Subject: Evaluation of South Tampa Stormwater Project
Tampa, Florida

August 1, 2026

Prepared by: Martin E. Millburg, P.E.
2414 West Watrous Avenue
Tampa, Florida 33629

ENGINEERING REVIEW OF SOUTH HOWARD STORMWATER PROJECT

Figure 6-13 – Proposed Hurricane Milton Flood Reduction, Parkland Estates (Future Phase)

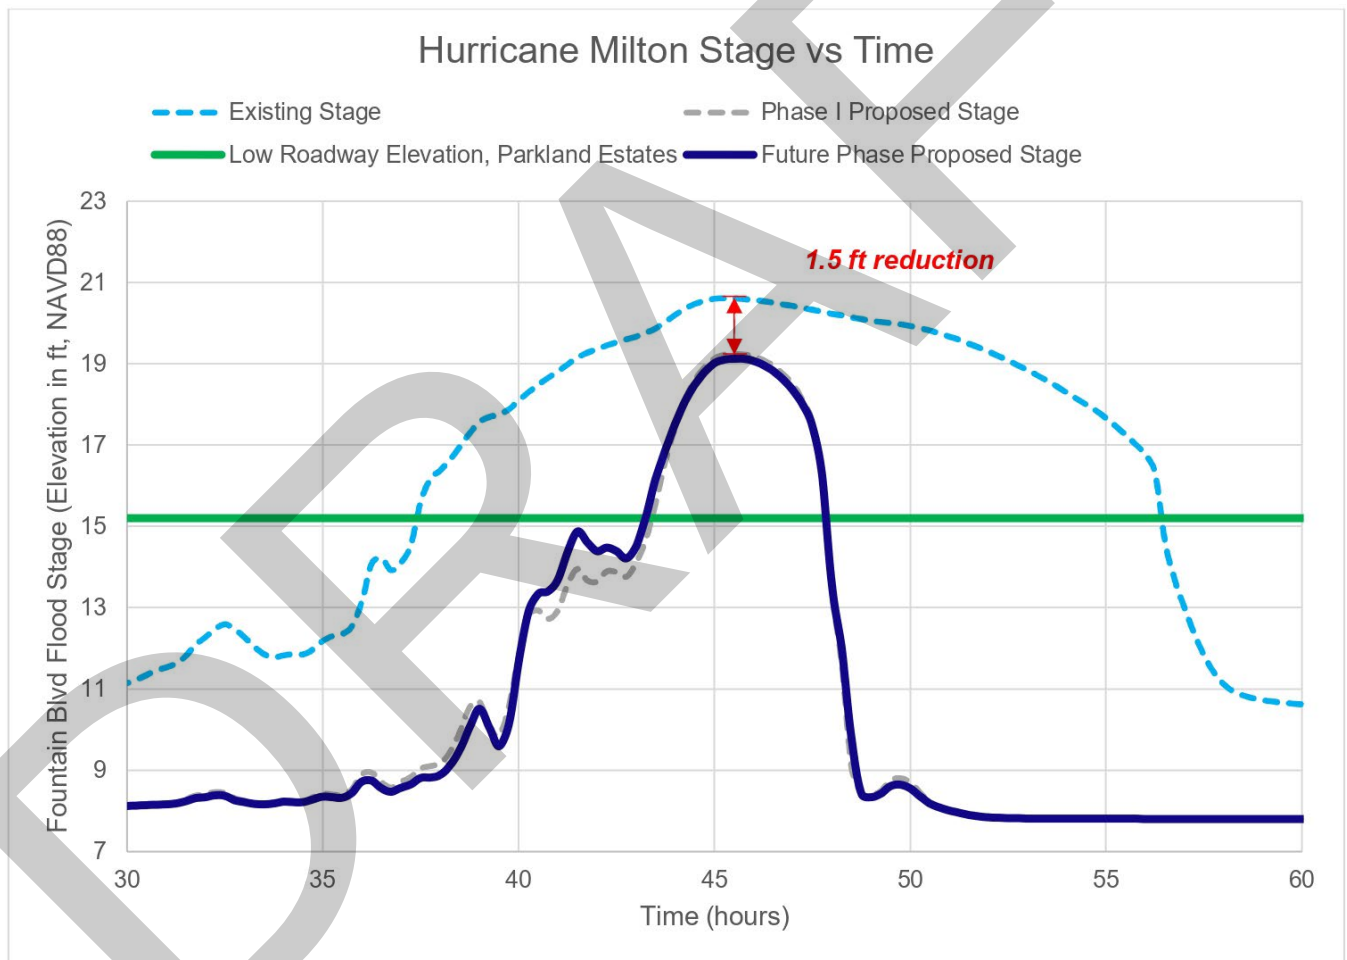
4. In return for the destruction of Howard Avenue for 2 to 3 years and spending in excess of \$100 million dollars, the project will reduce flooding from 5.5 to 4.0 feet during a Milton level event. When considering whether to go forward with this project, the benefit of a 1.5 feet reduction in flood levels needs to be considered relative to spending more than \$100 million.

- 4) \$100 Million gets a 1.5' Reduction in Flood Levels** - In return for the destruction of Howard Avenue for 2 to 3 years and spending in excess of \$100 million dollars, the project will reduce flooding from 5.5 to 4.0 feet during a Milton level event. See attached COT diagram.

Report of Core Borings Sheets – SR 618 over Howard Ave./Watrous Ave.

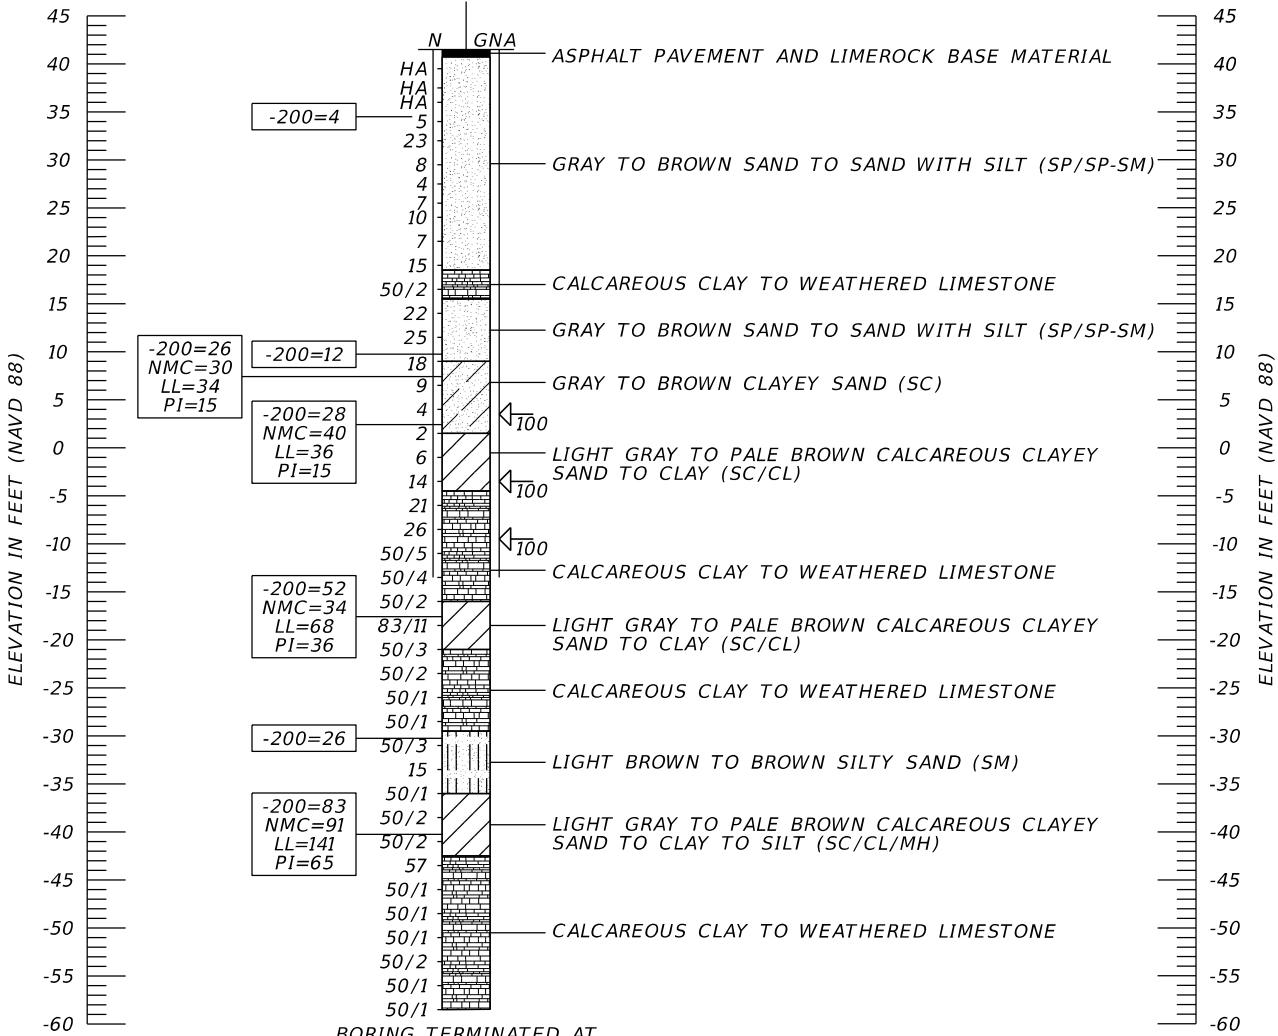
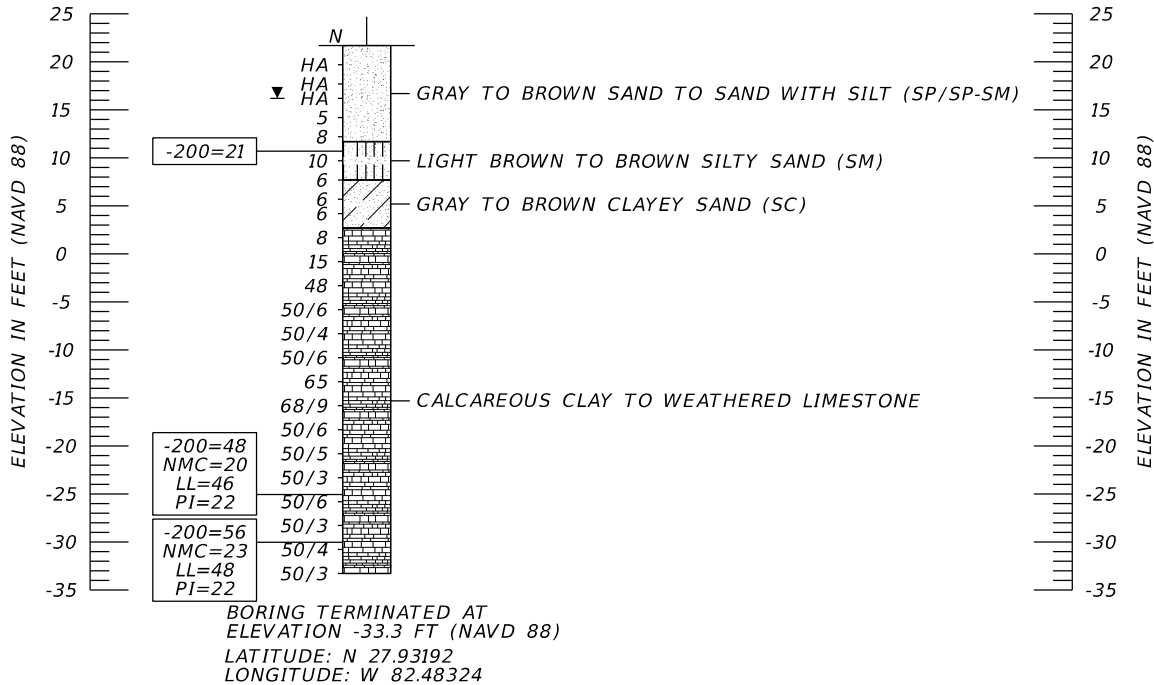
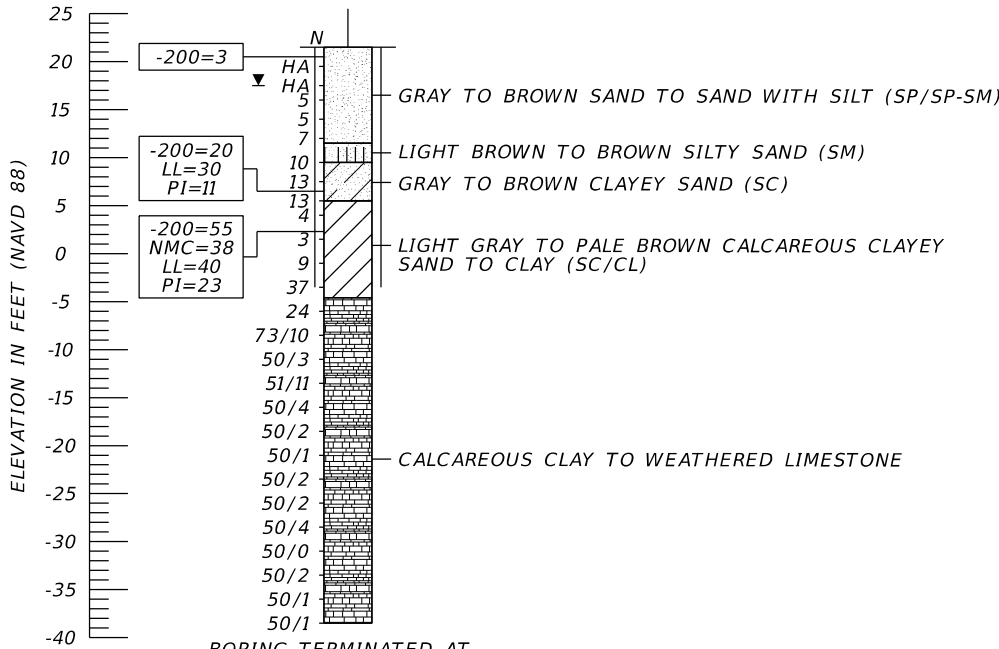
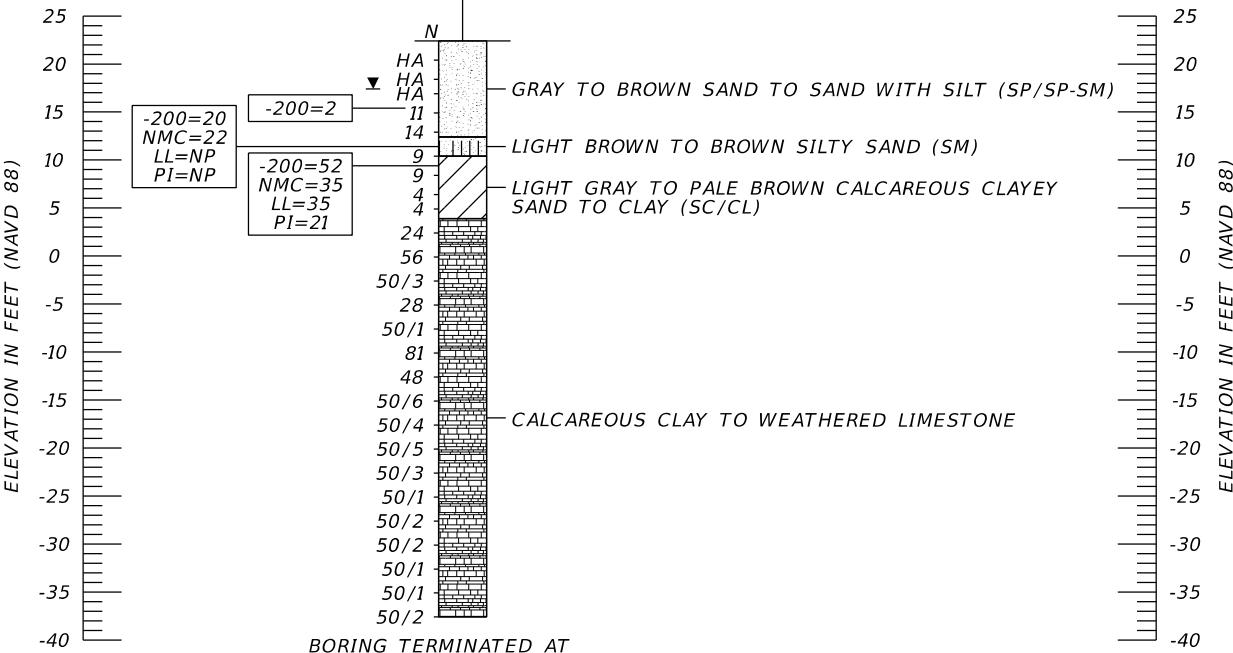
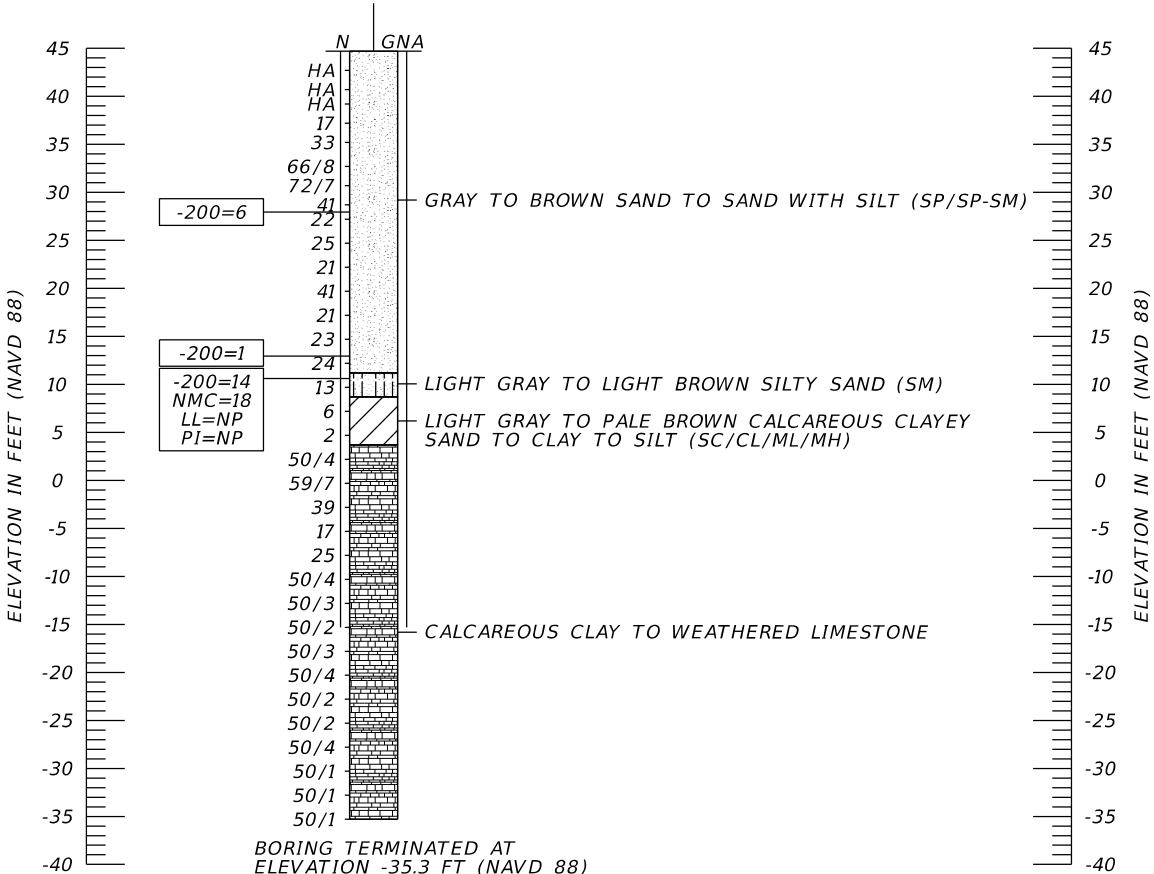
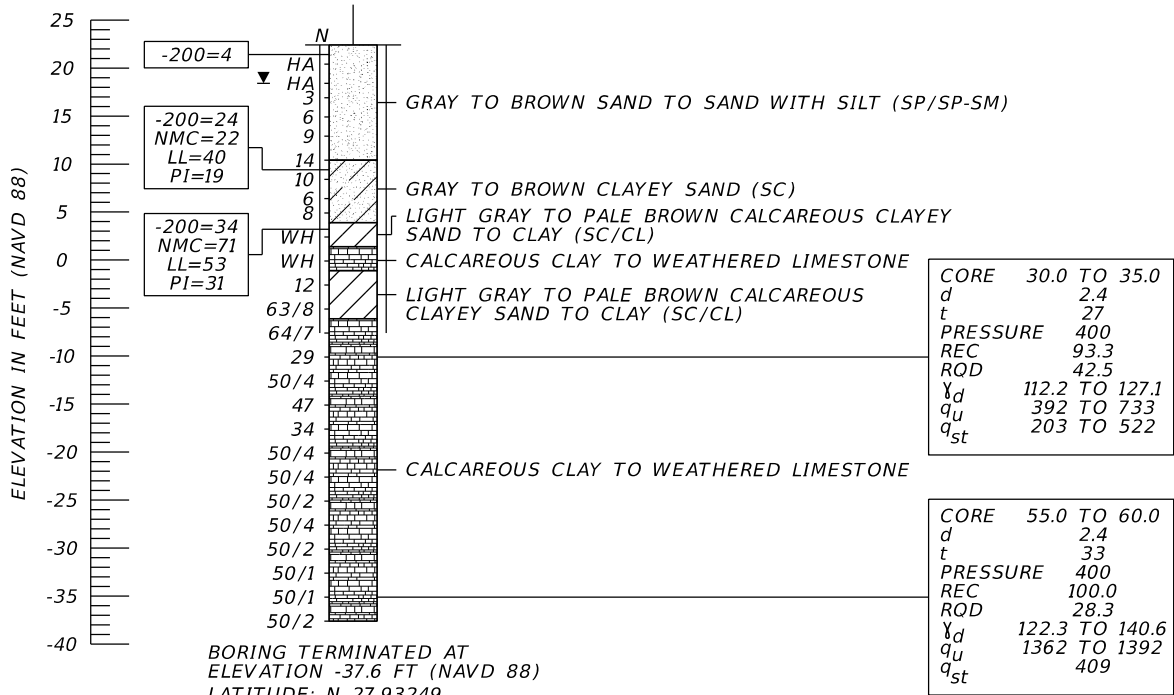
7. There is available geotechnical data from the Selmon Expressway expansion currently underway. That data shows that conventional measures for shoring the anticipated 20 feet excavation will be

significantly hindered by rock about 20 feet deep. Sheet piles are typically used to support the vertical walls of excavations, but they will not be able to be driven into rock. An unforeseen cost associated with shoring this excavation may develop during construction.

- 7) Existing Geotechnical Data** - There is existing soils data in the area of this project that was performed for the planned Selmon Expressway widening (see attached). These typically show groundwater about 3 feet deep, sands and clays in the upper 20 feet, underlain by weathered limestone. The ramifications to this project could be severe. At Southview, the bottom of the BC is at least 18 feet deep. The excavation will need to be maintained by temporary retaining walls. If rock is present at 20 feet, the retaining walls may not be able to advanced deep enough to support the excavation. Tiebacks, possibly extending 50 feet or more back onto private property along Howard Avenue, may be the only possible cost effective means of supporting the retaining walls. The process of getting permission from these private property owners, many of whom staunchly oppose this project, could take months or more, or may not be able to be obtained. Another option that may be required to support the excavation walls would be installation of a combi-retaining wall. This wall is a combination of a retaining wall with drilled shafts embedded into rock to support the wall. This process would result in significant delays and be relatively costly. There is no evidence that this issue has been addressed, suggesting a low level of design expertise and/or experience. If this issue is present, as suggested by existing soils data, discovery during construction could result in significant delays to the project while alternatives for supporting the excavation are evaluated. Significant additional cost will be incurred by the COT, with no recourse other than to agree to whatever measures may be proposed to get the project moving again.

Available geotechnical data shows about 30 to 50% of the soils to be excavated to will consist of clayey soils. Clayey soils are not well suited for backfilling, so imported sandy soils will be required to backfill the box culvert excavation. This soil will need to be brought back in and backfilled, with about 30 to 50% of the material needing to be purchased select backfill. This issue could have a significant negative impact on project costs, and needs to be thoroughly evaluated in the current design phase.
